Ref: New England Wind 2 Connector Draft Environmental Impact Report (DEIR) Supplement

Commonwealth Wind, LLC, a wholly owned subsidiary of Avangrid Renewables, LLC, (the “Company”) is pleased to submit the attached Supplement to the Draft Environmental Impact Report (DEIR) submitted on July 14, 2023 for the New England Wind 2 Connector (the “Project”). This DEIR Supplement describes a minor engineering modification designed to reduce potential future climate change-related impacts to Project infrastructure proposed at the landfall site. Specifically, one transition joint bay (TJB) buried beneath the southern end of the paved parking lot will be lowered by an additional two feet. This engineering design modification will bring the TJB burial depth to four feet below grade, preventing its exposure due to modeled extreme future storm events associated with climate change. As a result, Project infrastructure proposed at the landfall site would have no effect on modeled extreme future storm impacts at the landfall site throughout the life of the Project.

This DEIR supplement provides three updated attachments to replace those in the original DEIR submittal:

- Updated Attachment C3 La

Figure 1 – Bed Level Change, 2050 Back-to-Back Storm Event Scenario

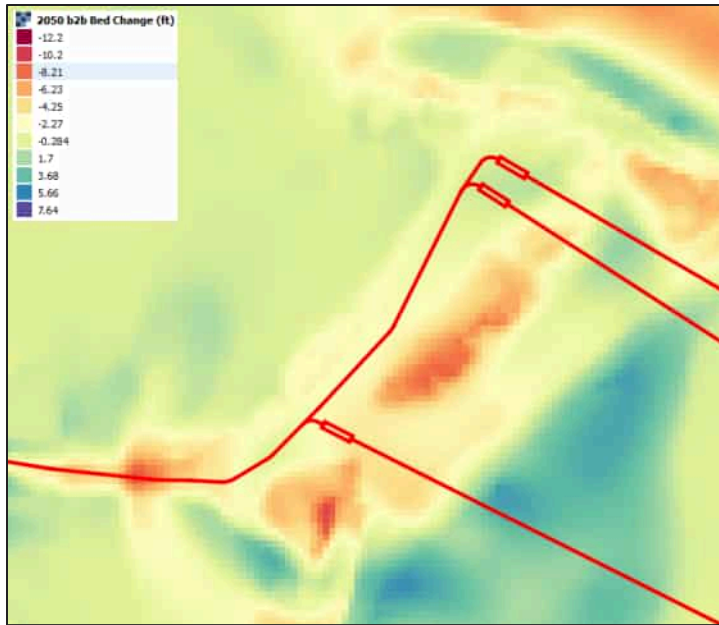
Figure 1 illustrates modeled worst-case post-storm bed level change (in feet) from the 2050 back-to-back storm event scenario by comparing pre- and post-event ground elevations; negative values indicate erosion, and positive values indicate accretion. Figure 2 presents potential wave forces (lb/ft²) on a structure using the Goda equation (USACE Coastal Engineering Manual Table VI-5-53) with the modeled peak wave conditions from the 2050 200-year storm event. Proposed structure locations are shown in red. As set forth in the RPS reports, this worst-case storm scenario is extreme and would damage the coastline in many parts of Cape Cod, not just Dowses Beach, and would do so regardless of the project.

Worst-case erosion values along proposed structure locations were modeled to be as high as 8.9 feet (2.7 meters), but this value would be isolated to a single area on the causeway that is likely minimally erodible. At the South Transition Joint Bay, the maximum modeled erosion would be 3.6 feet (1.1 meters). Maximum potential wave forces at proposed structure locations ranged from 250 to 410 lb/ft². Additionally, the RPS worst-case modeling indicated that the 2050 200-year storm event water level could potentially reach a maximum of 14.6 feet (4.4 meters) NAVD88, which includes sea level rise, tides, and storm surge. At this elevation, the entire Dowses Beach Area, including its causeway and parking lot, would be submerged.

A conservative interpretation of the erosion illustration (Figure 1), indicated the maximum erosion at the South Transition Joint Bay (vault) to be 3-4 feet at the east end of the vault. The North and Center vaults experienced minimal (less than one foot) erosion or accretion. The maximum wave pressure illustration (Figure 2) indicated a force of 400 lb/ft² at the vault locations. The vaults included in the Project's current conceptual design were 8.5 feet in height and were placed 2 feet below grade. Each includes two access hatches that will be connected to the vaults by extension collars. The erosion at the southern vault, on the order of 3-4 feet, would expose the top 1 to 2 feet of the vault, during the 2050 storm event.

1. Lower the South vault elevation so that the vault top at or below the modeled erosion level.
2. Extend the vault extension collars to the accessways to accommodate this vault elevation change.
3. Anchor the South vault to the bottom seal slab and design the slab to resist floatation uplift forces.
4. Coordinate the vault manufacturer's design to accommodate the hydraulic pressure resulting from the 14.6 feet water level plus the downward wave pressure acting downward on the top of the vault.

Attachment: Attachment 1 – Culvert Crossing & Duct Bank Transition

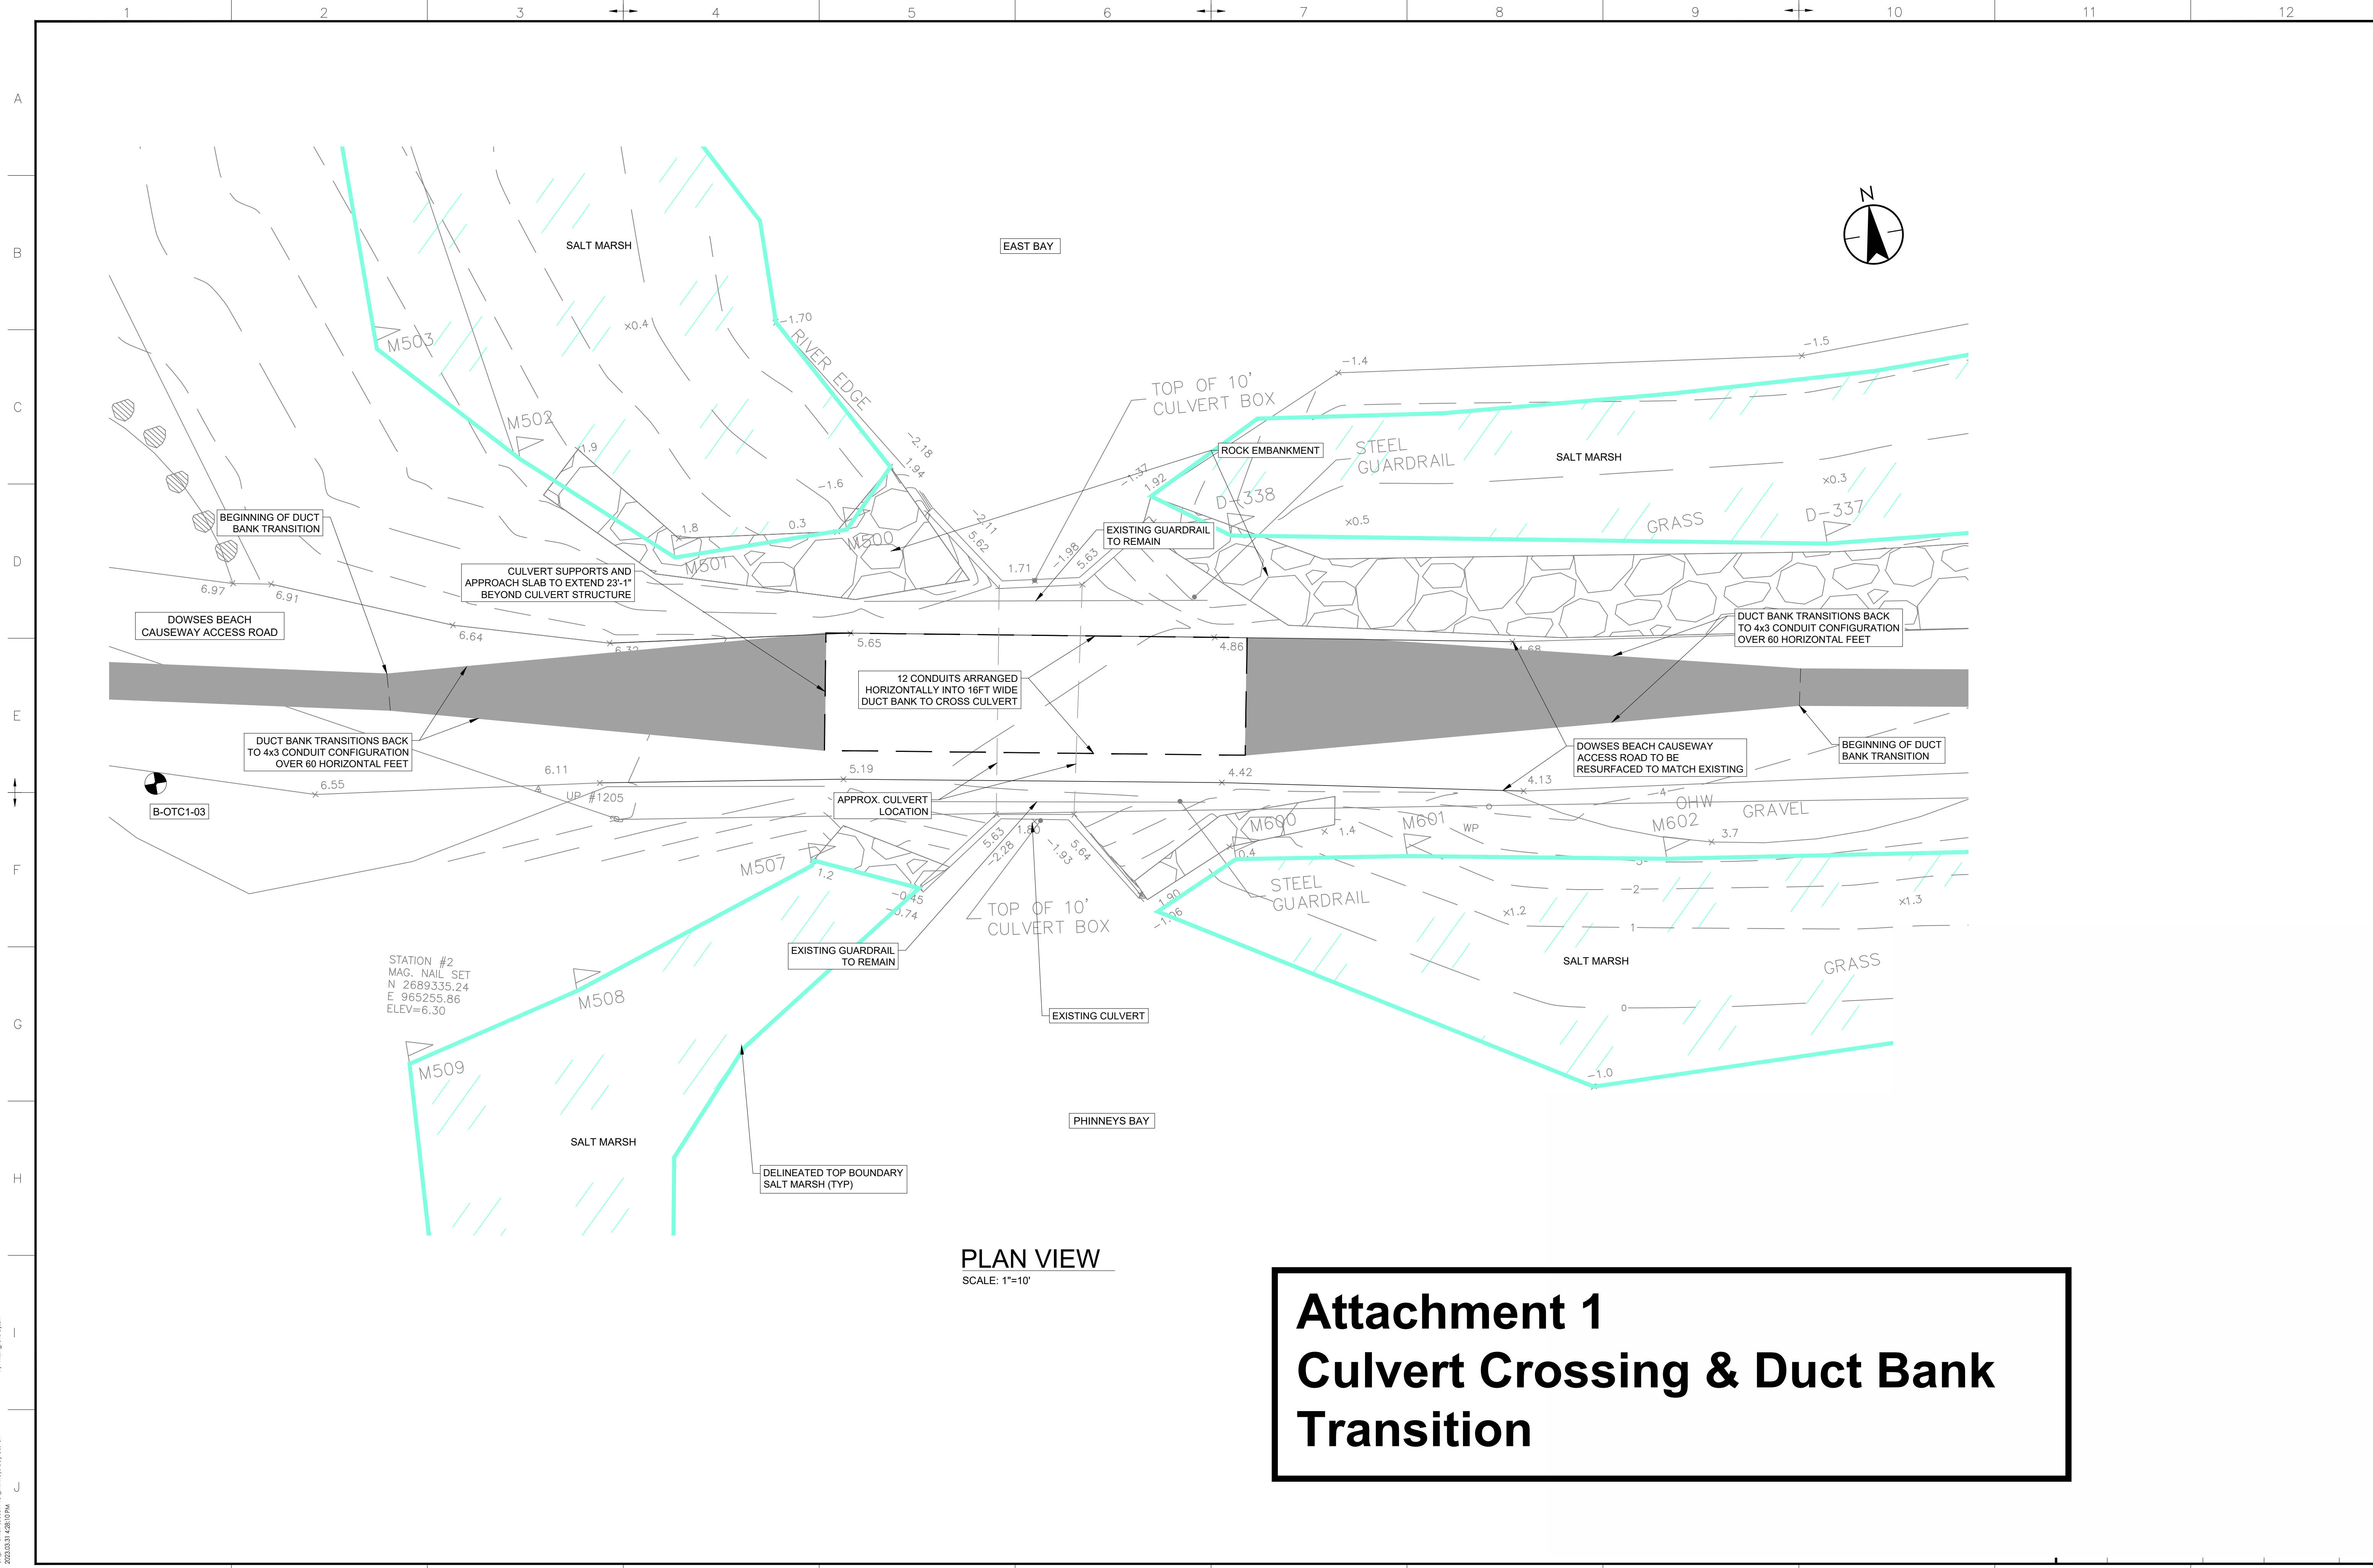
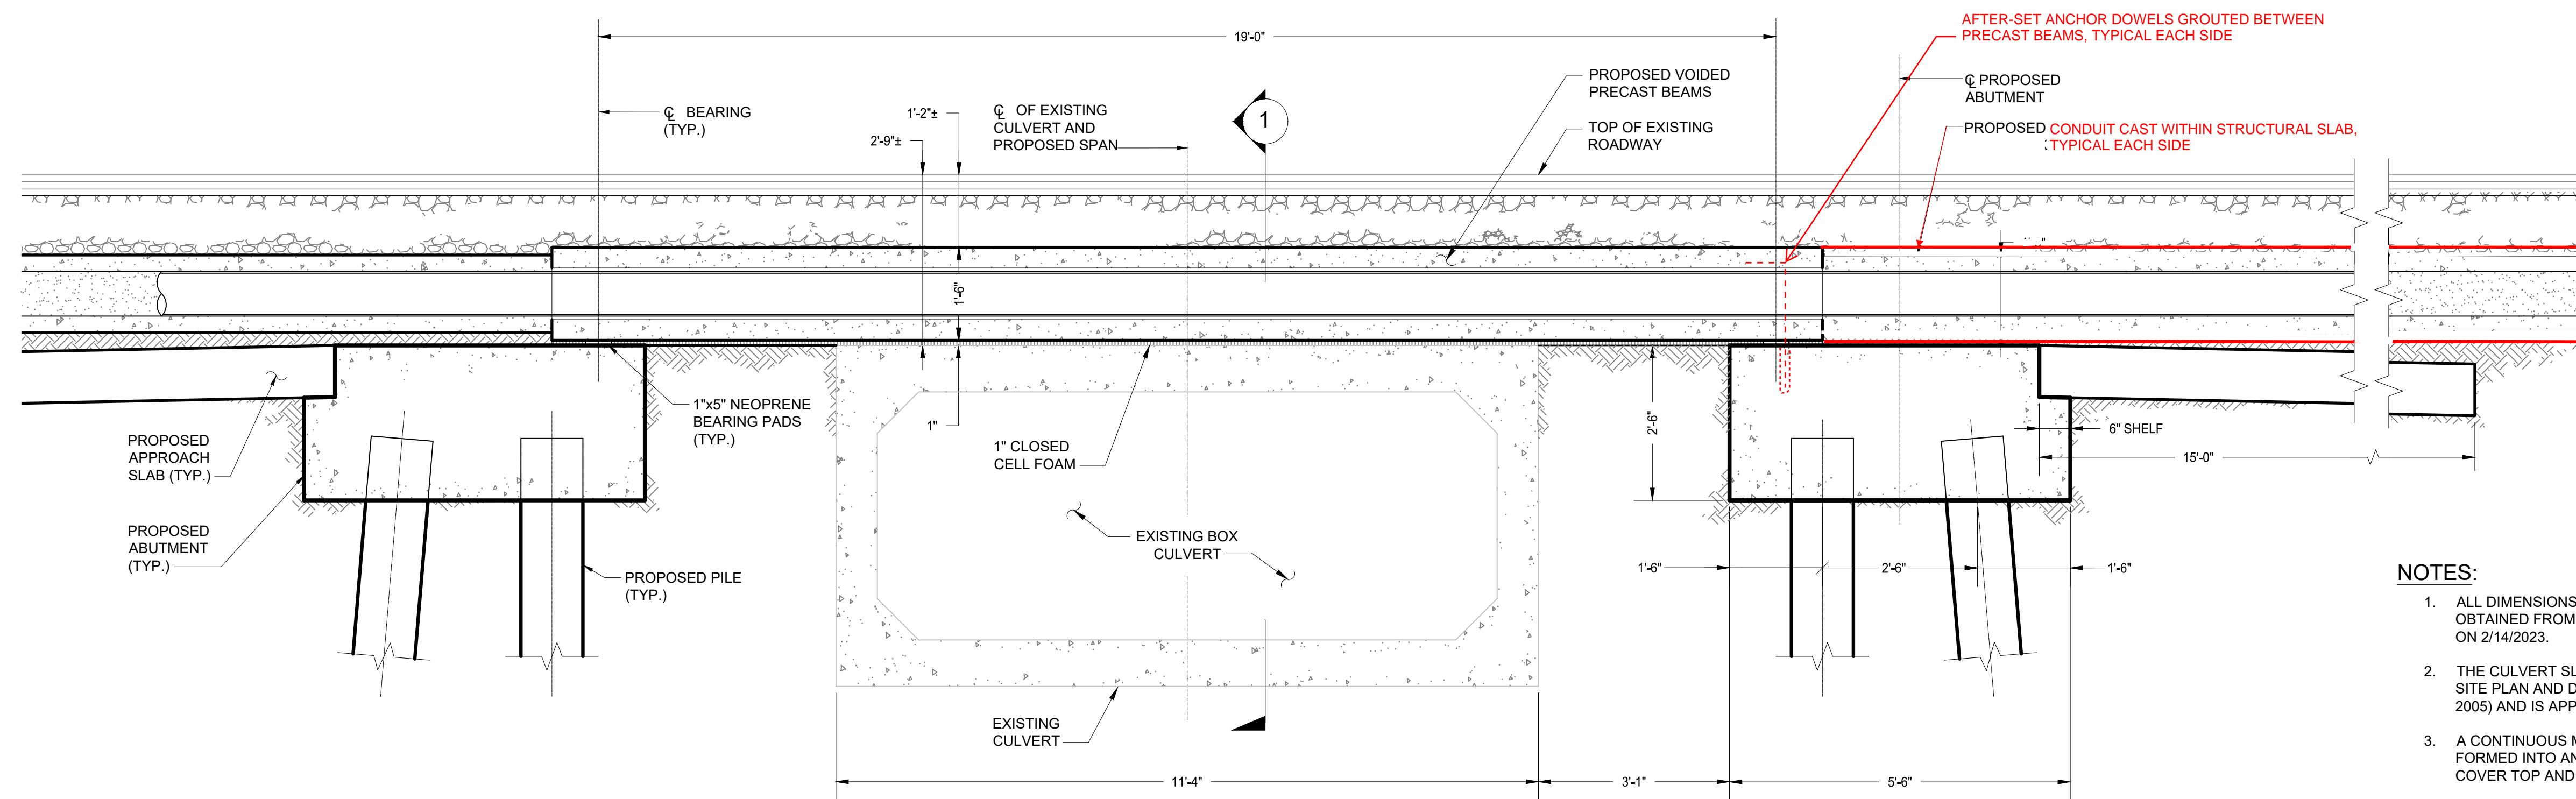
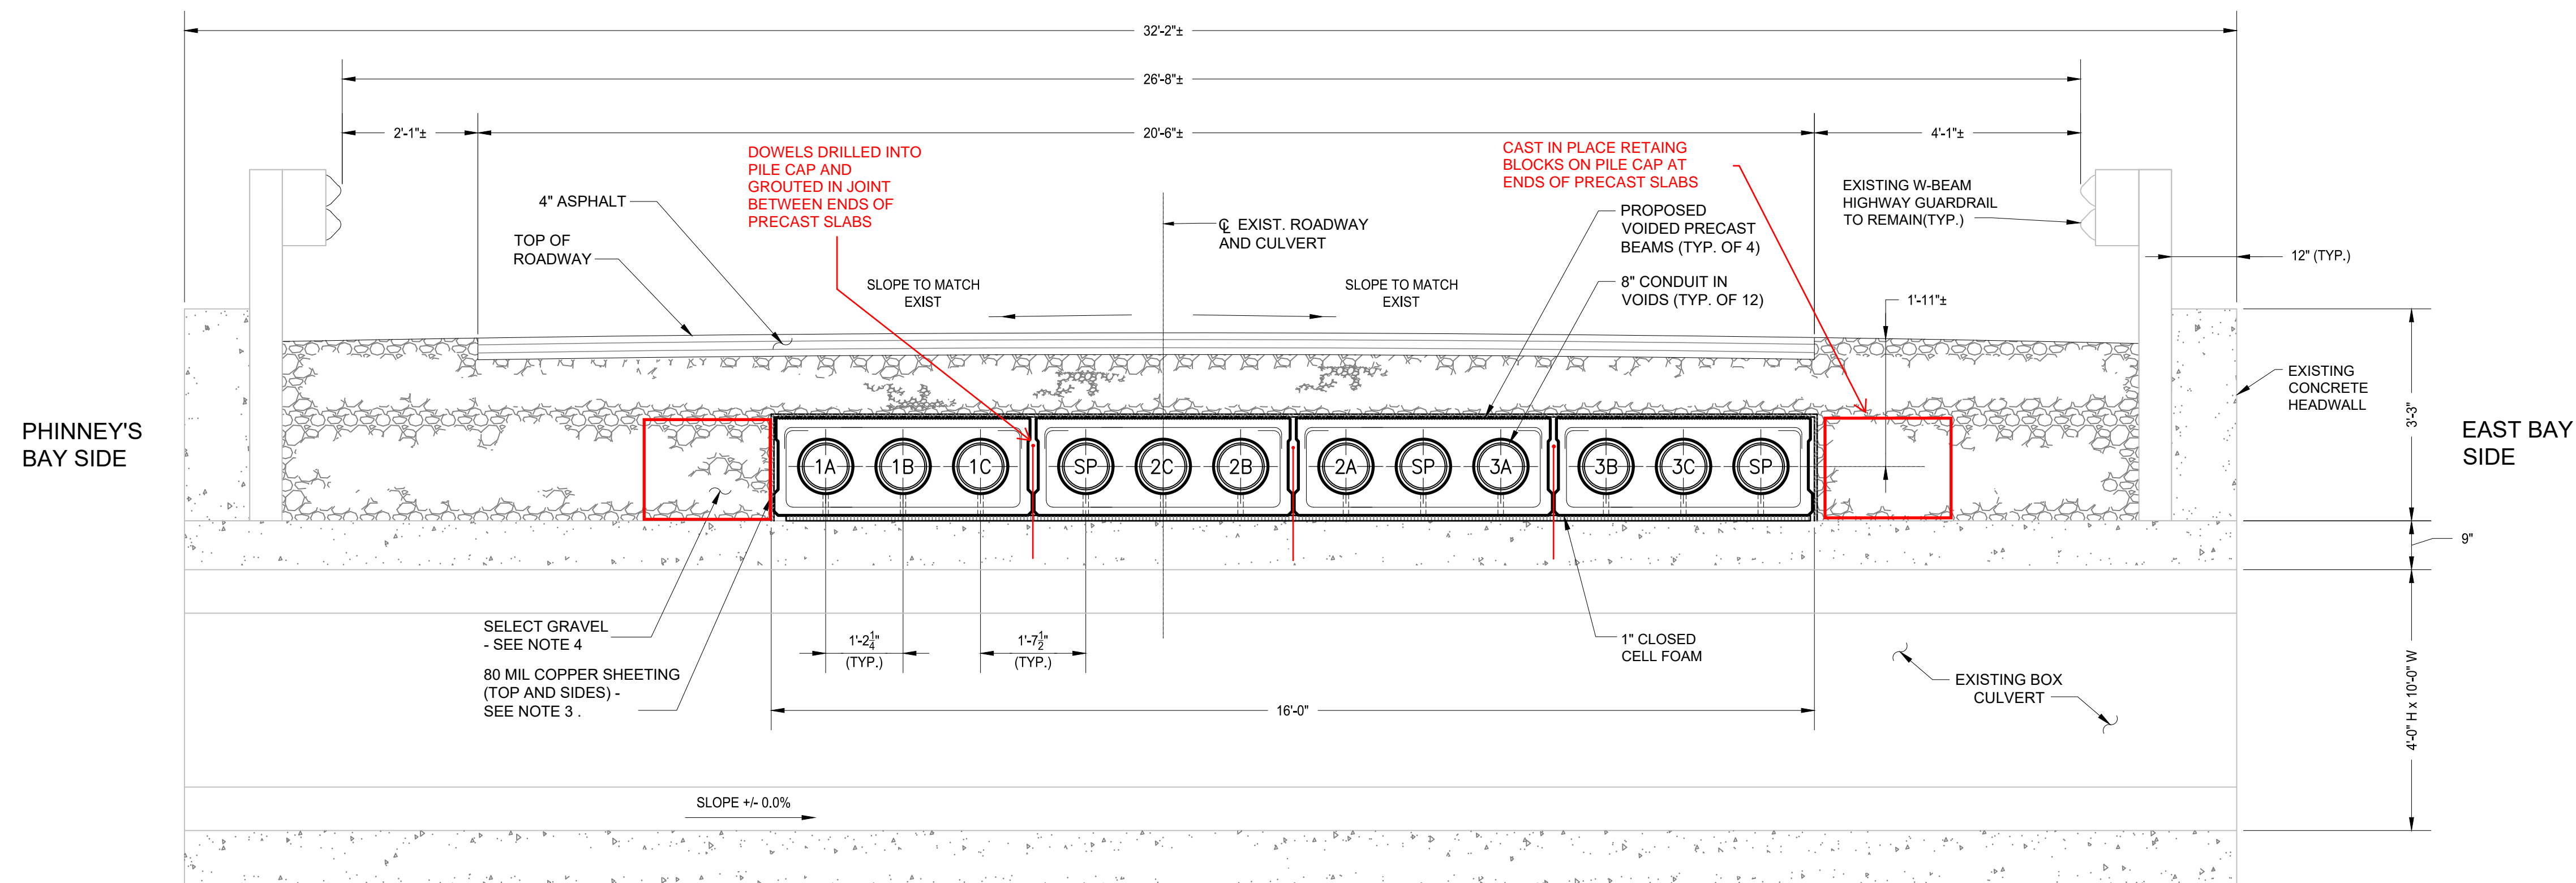
- Erosion levels greater than 7 feet – RPS modeling identified an isolated potential maximum 8.9-foot erosion depth at the east end of the causeway under extreme worst-case storm event conditions. Since the duct bank cannot be lowered deeper than 7 feet, protection can be provided by permanent steel sheet pile on the sides of the duct bank and a structural concrete top slab just above the duct bank. Refer to Attachment 1.

Figure 1 indicates that erosion in the vicinity of the existing causeway, leading to the landfall site, could be a maximum of 3.25 feet; under these conditions, the duct bank, in a 3W x 4H conduit configuration, would not become exposed. However, to cross the existing culvert within the causeway, the duct bank conduit would rise and transition from a 3W x 4H to a 12W x 1H configuration on their approach to the hollow core slabs that bridge over the culvert, and in this location would have a limited depth of cover under the roadway pavement and would become exposed with the maximum modeled erosion. This duct bank transition can be protected from wave forces by an enclosure of PZ40 steel sheet pile walls and a 15 inch cast-in-place top slab. The sheet pile would form permanent sides of the excavation for installing the conduits with customary installation techniques. Once the duct bank construction is completed and any temporary bracing removed, the structural concrete slab would be placed directly on top of the duct bank conduits. As the duct bank rises, as it approaches the bridge crossing, the top of the slab would be just below the bottom of the roadway pavement. The reinforced structural concrete slab will be designed to support roadway traffic loads and be secured by steel angle segments, welded to the sheet pile.

As the conduits achieve the 12W x 1H configuration just before entering the hollow core slabs, the structural slab will be cast around the ducts with reinforcement above and below the conduit. The cross section is similar to the post-tensioning tendons of the hollow core section except that it will be a conventional cast-in-place slab with reinforcement. The cast-in-place slab spans transversely and is supported by the sheet pile sides of the permanent protection. Please refer to Attachment 1 for a graphical depiction of this concept.

The sheet pile would be installed a minimum 20 feet below all excavations. The sheet pile size and required temporary bracing for the construction will be determined during detailed design.

Over the existing culvert within the causeway, the conduits will be placed in precast concrete hollow core slabs that span over the culvert and will be supported by new pile caps on each side of the culvert. The hollow core slabs and pile cap will form a structure, independent of and not connected to, the existing culvert. The ends of the hollow core slabs would be anchored and secured to the pile cap support with dowels placed between the plank joints and by end blocks on the pile cap to resist lateral and uplift forces.
